I-5 / 4th ST and 88th ST NE
Corridor Improvements

Tulalip Tribes Project No. 2026-014

ADDENDUM NO. 4 – August 5, 2026
to
Request for Bid Proposals

I-5 / 4TH ST AND 88TH ST NE
CORRIDOR IMPROVEMENTS
VOLUME 4 OF 4
RETAINING WALL PLAN AND PROFILE
WALL W18 SEW WALL

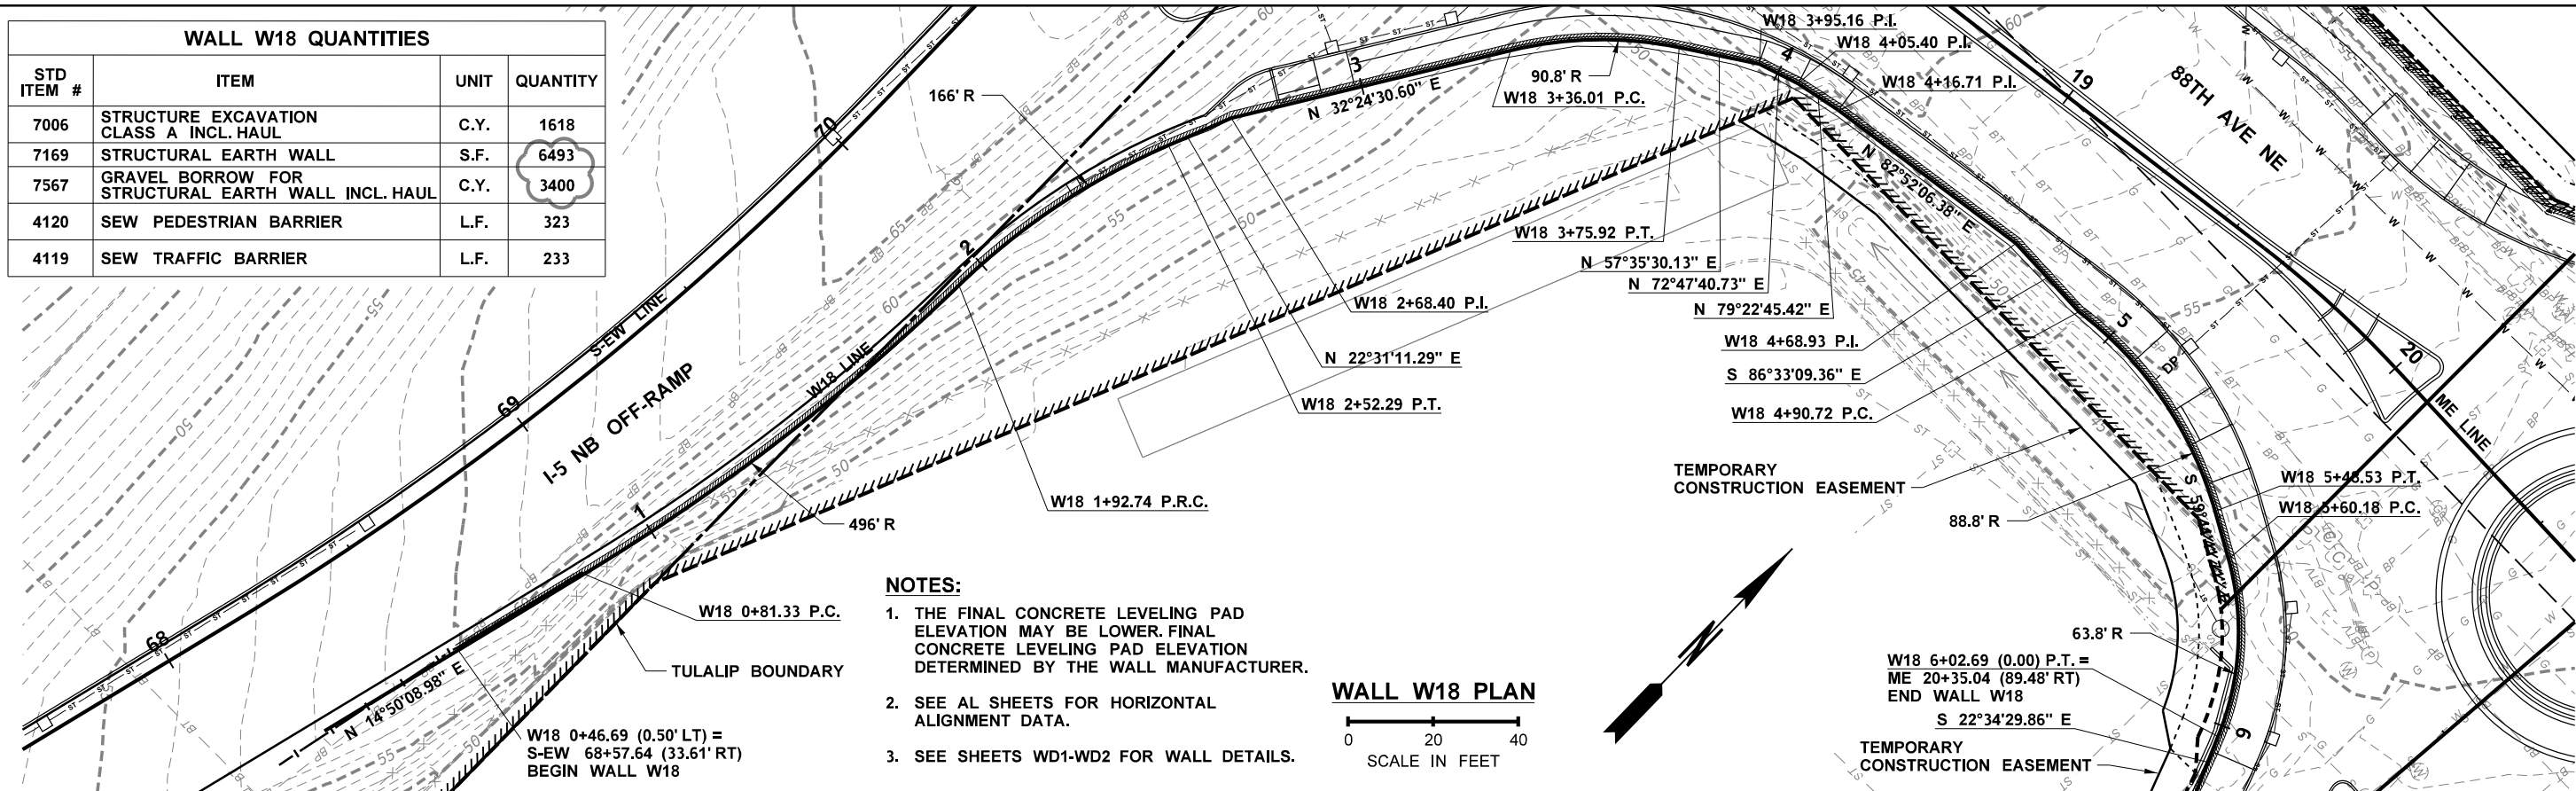
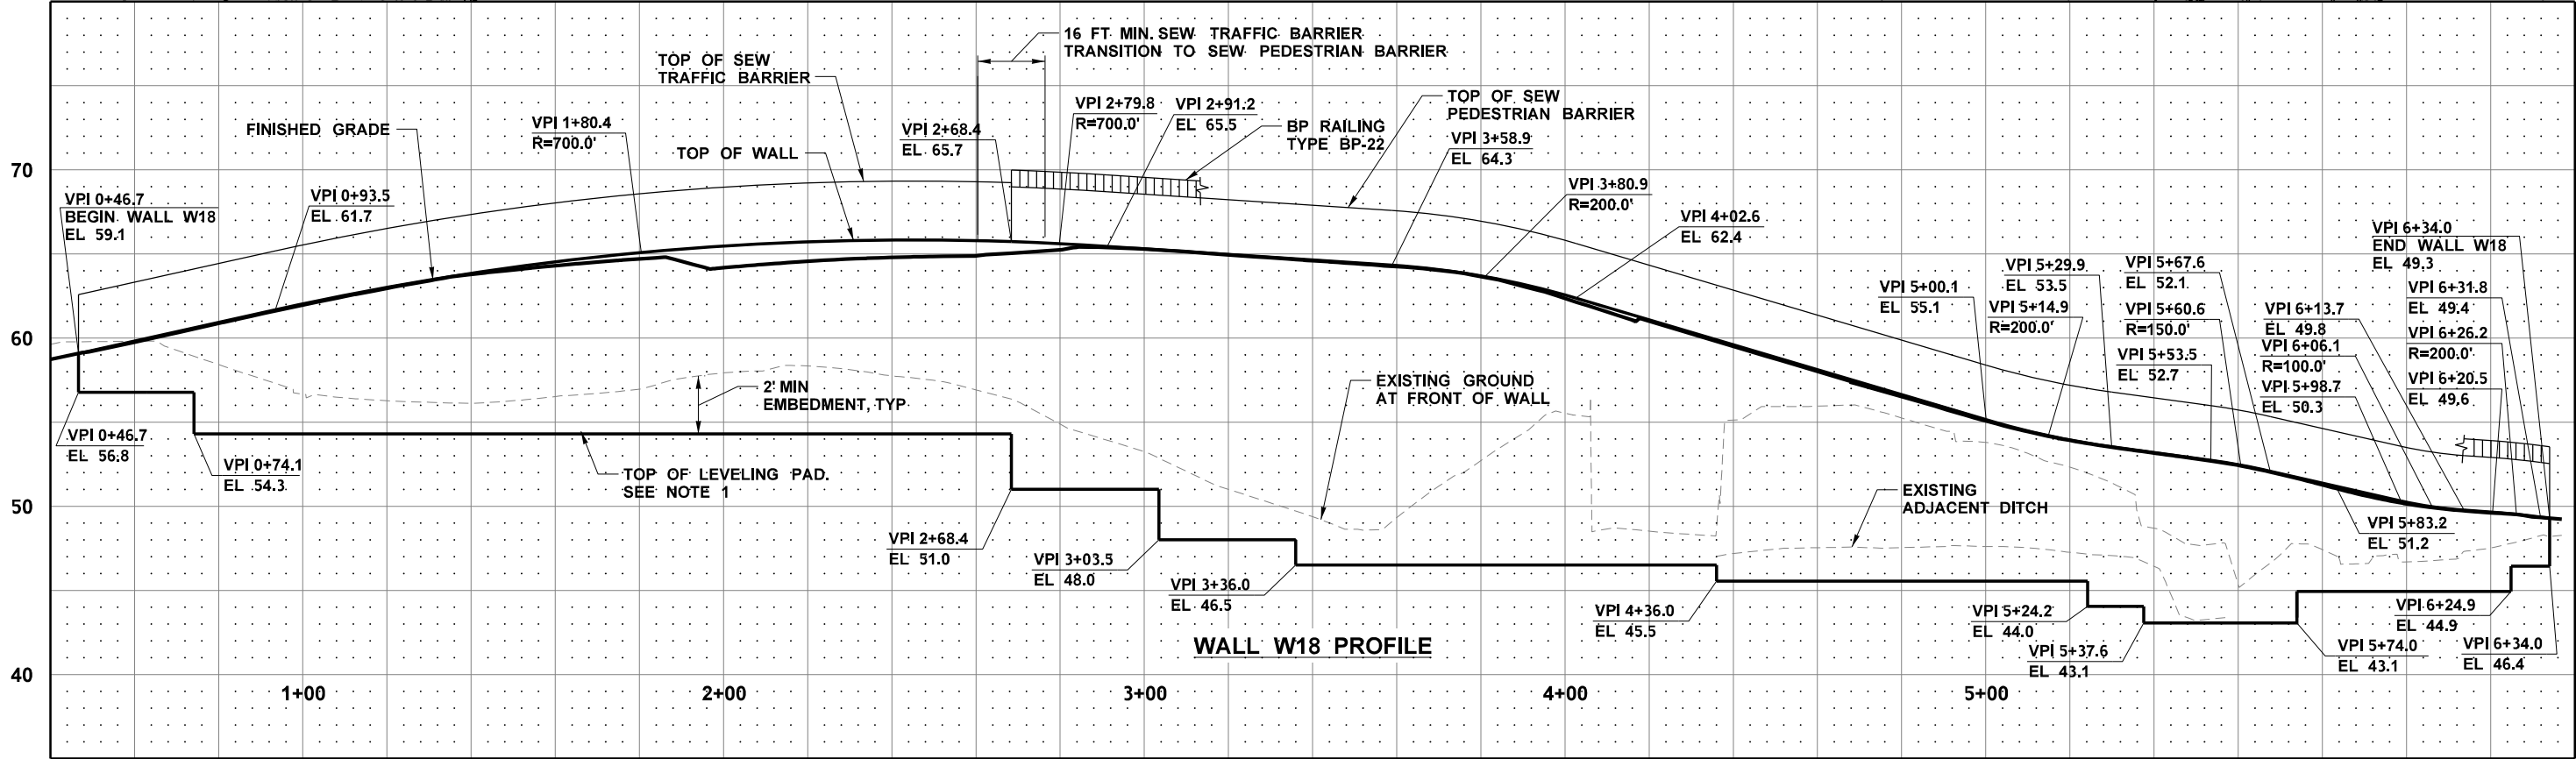
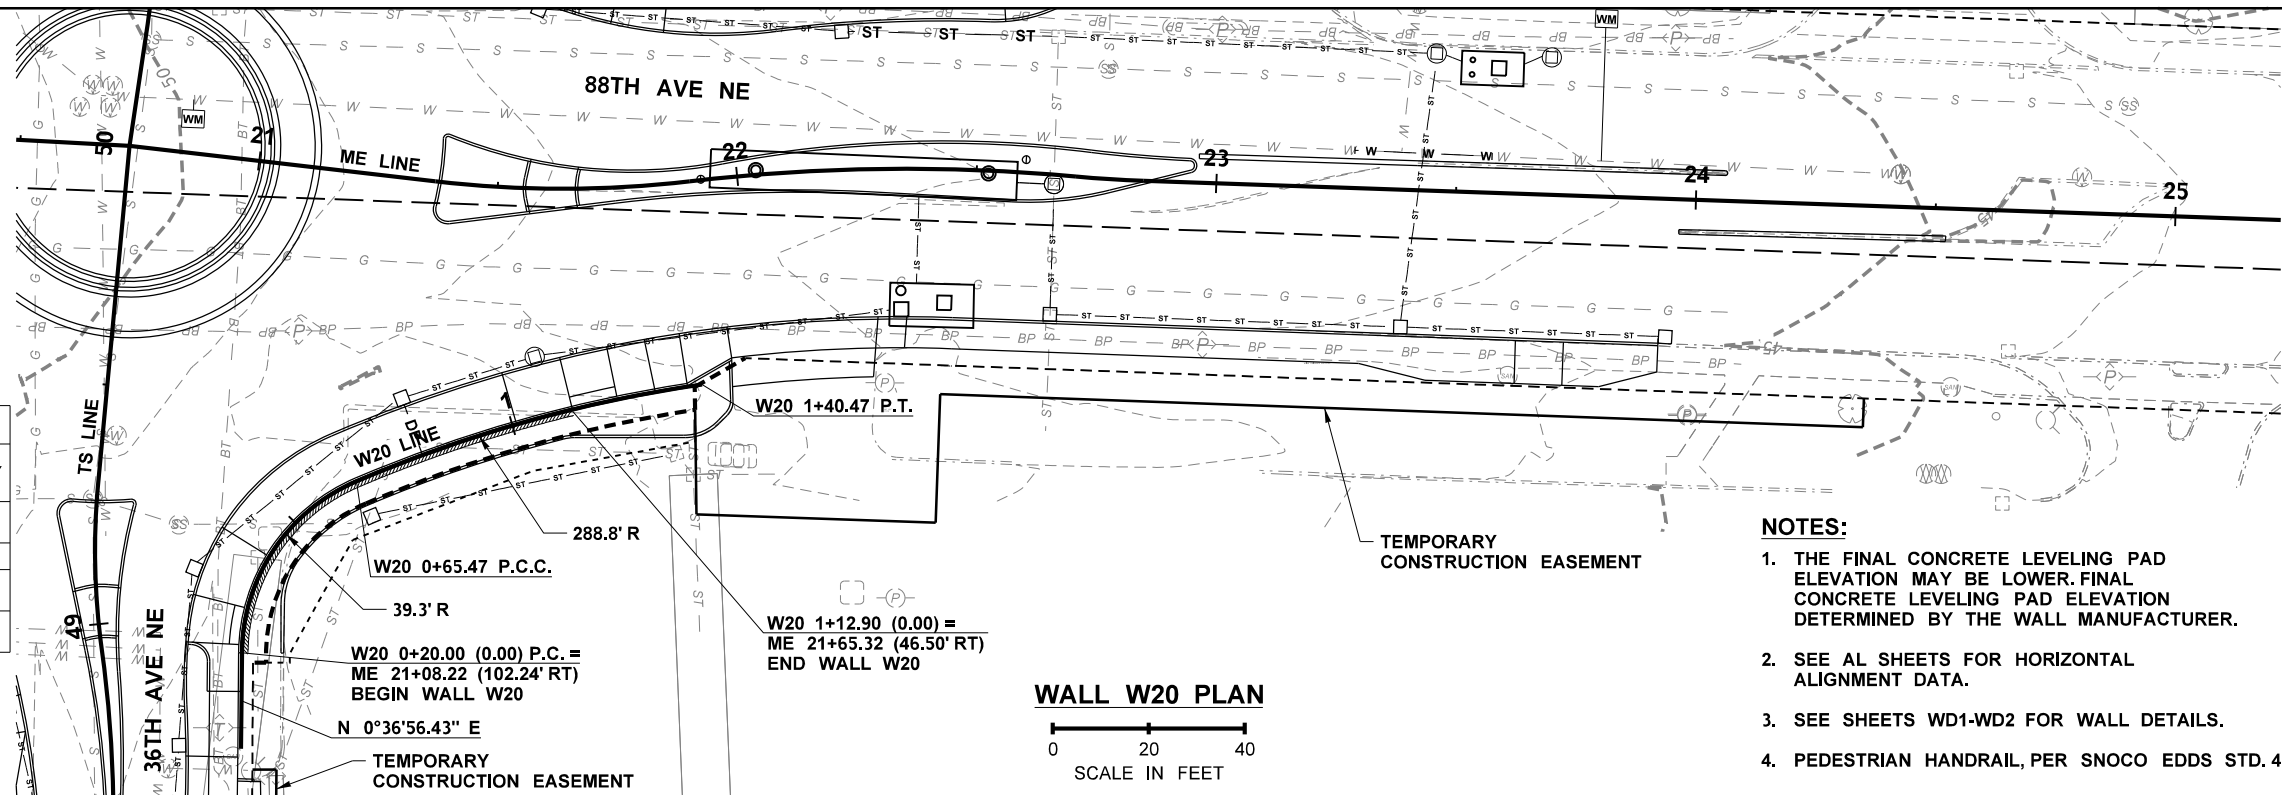
1. Volume 3
Sheets ILW8, RRFB Details - WSDOT; ILW9, Illumination & RRFB Notes and Schematics – WSDOT; SN2, SN4, SN5, Signing Plans; SS1-SS4, Sign Specifications.
2. Volume 4
Sheets ILW8, RRFB Details - WSDOT; ILW9, Illumination & RRFB Notes and Schematics – WSDOT; SN2, SN3, SN5, SN6, Signing Plans; SS1-SS4, Sign Specifications; WA1-WA6 SEW Wall plans.
